ENGINE – PROVIDE INSTRUCTIONS TO CHANGE THE DATA ENTRY PLUG ASSEMBLY AND THE ELECTRONIC ENGINE CONTROL TO OBTAIN A V2527E-A5 RATING – CATEGORY CODE 8 – MOD.ENG-72-0231

V2500-ENG-72-0231

SERVICE BULLETIN

Location of the Data Entry Plug Assembly
Fig.2

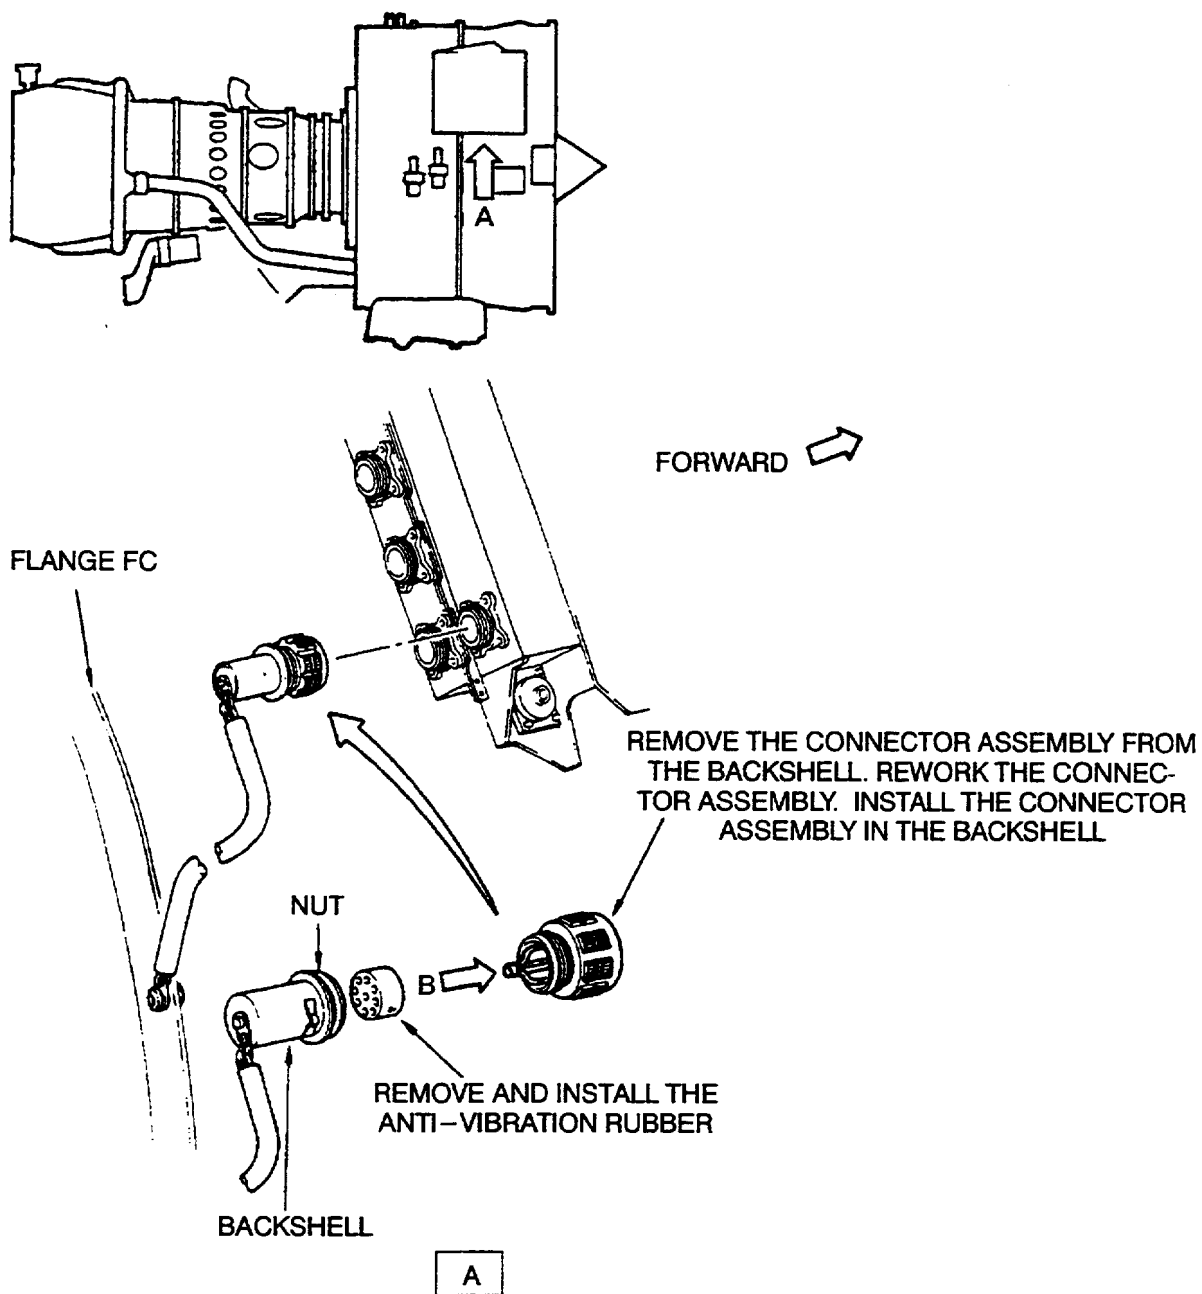
- A. Disassemble the Data Entry Plug Assembly, PN 2A3106, by the procedure specified in Reference (4), Chapter Section 73-22-35, Disassembly, and Figure 2.

- C. Assemble the Data Entry Plug Assembly by the procedure specified in Reference (4), Chapter Section 73-22-35, Assembly, and Figure 2.
- D. Do a check of the wiring by the procedure specified in Reference (4), Chapter/Section 73-22-35, Assembly.
- E. Mark the Data Entry Plug Assembly by the procedure specified in Reference (4), Chapter/Section 73-22-35, Assembly, and Figure 2.
- F. Install the Data Entry Plug Assembly by the procedure given in Reference (3), Chapter/Section 72-00-32, Installation-30, Config-2.
- G. Incorporate the intent of Reference (1), V2500-ENG-73-0080, if this was not done before.
- H. Do the applicable engine test by the procedure specified in Reference (3), Chapter/section 71-00-00, Testing 11, Config-2.
- I. Install the new engine Identification Plate by the instructions given in Reference (3), Chapter/Section 71-00-00, Testing-11, Config-2.

Modification of the Data Entry Plug Assembly To Obtain The V2527E-A5 Rating
Fig.4

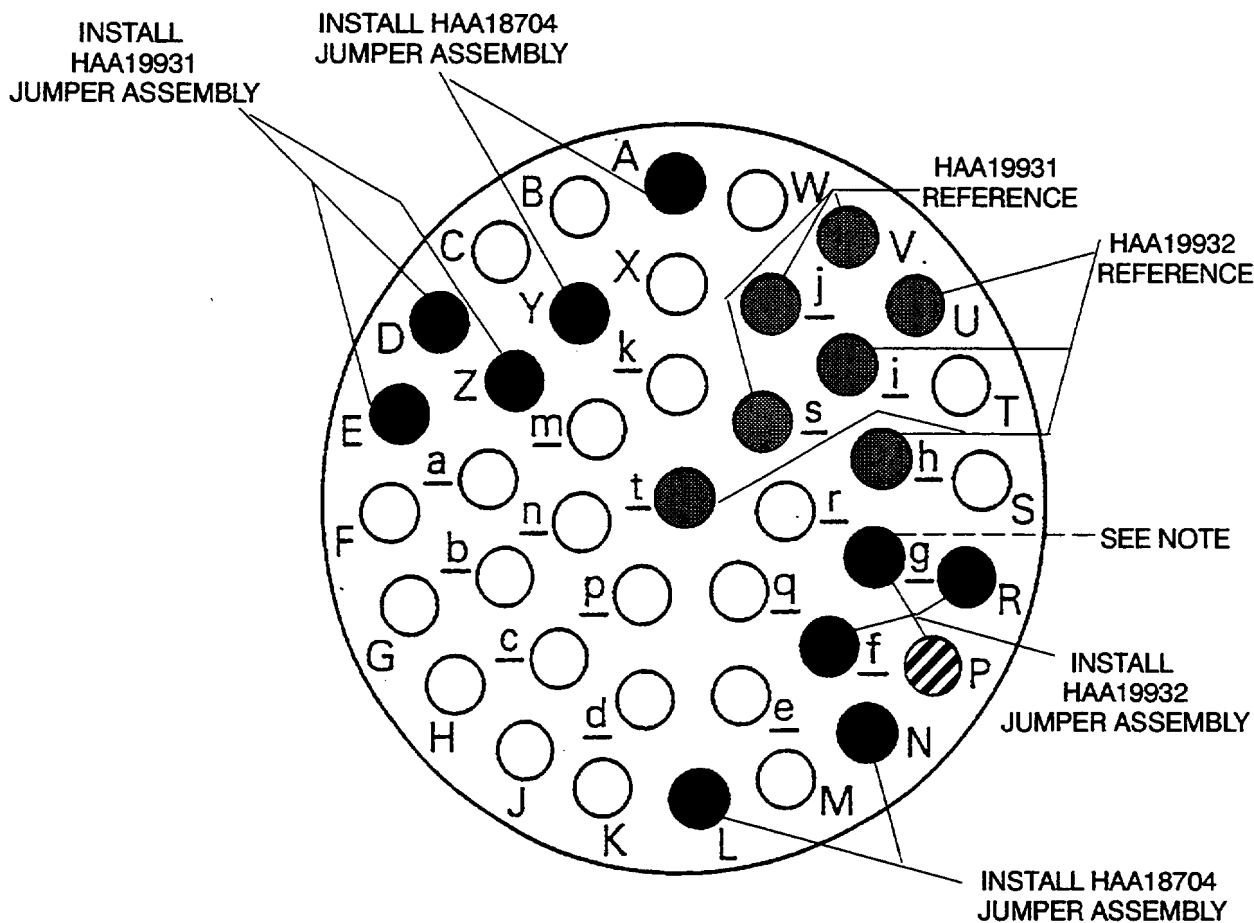
- (1) Do a modification to the Data Entry Plug Assembly, PN 2A3106 (1 off) (Reference (2), Chapter/Section 73-22-35, Figure/Item No. 01-100) by Figure 4 and the procedure that follows:

Procedure	Supplementary Information
(a) Remove the Sealing Plugs, Contacts and Jumper Pins necessary to permit you to wire the No. 35 variant	Refer to Figure 4. Use the approved procedure in Reference (4), Chapter/Section 73-22-35, Repair-001 (VRS 3500).
(b) Install the applicable jumper assembly in the pin holes specified in Table 1.	Refer to Figure 4. Use the approved procedure in Reference (4), Chapter/Section 73-22-35, Repair-001 (VRS 3500).

Connections		Jumper Assembly Required
A-Y	(Channel A)	HAA18704
D-Z-E	(Channel A)	HAA19931 or HAA19932 (See Note)
N-L	(Channel B)	HAA18704
f-g-R	(Channel B)	HAA19931 or HAA19932 (See Note)

NOTE: The pin connections for the variant No. are the only connections that are changed when you do this Service Bulletin. The pin connections for the EPR modifier and the engine serial No. DO NOT CHANGE. However, in some cases, connector holes g and Z are used in the EPR modifier wiring. When this occurs, use jumper assembly HAA19932 instead of HAA19931 to obtain variant No. 35 while retaining the same EPR modifier. (Determine current EPR modifier pin connections by referring to Reference (3), Chapter/Section 71-00-00 Testing-11, Config-2.)

-  PIN CONNECTIONS FOR VARIANT NO.35. THESE MUST BE WIRED TO COMPLETE THIS SERVICE BULLETIN
-  PIN CONNECTIONS FOR ENGINE SERIAL NO. V10122 (EXAMPLE ONLY) NO CHANGE
-  PIN CONNECTIONS FOR EPR MODIFIER 08 (EXAMPLE ONLY) NO CHANGE

Family Tree - Electronic Engine Control Ref. Catalog Sequence No. 73-22-34 Fig. 01
Item 100
Fig.5

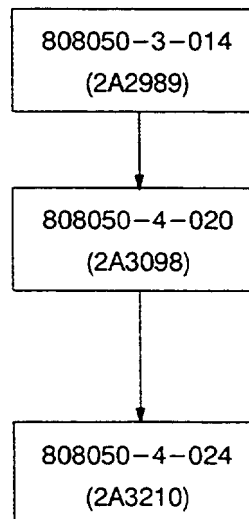
V2500-ENG-73-0052
PROVIDE A NEW ELECTRONIC
ENGINE CONTROL WITH SCN-9A
VERSION 021/121 SOFTWARE
CONFIGURATION AND HARDWARE
CHANGES TO ADDRESS NACELLE
LEAKAGE REQUIREMENTS

V2500-ENG-73-0080
PROVIDE A NEW ELECTRONIC
ENGINE CONTROL WITH SCN-10A
VERSION 026/026 TRIMS
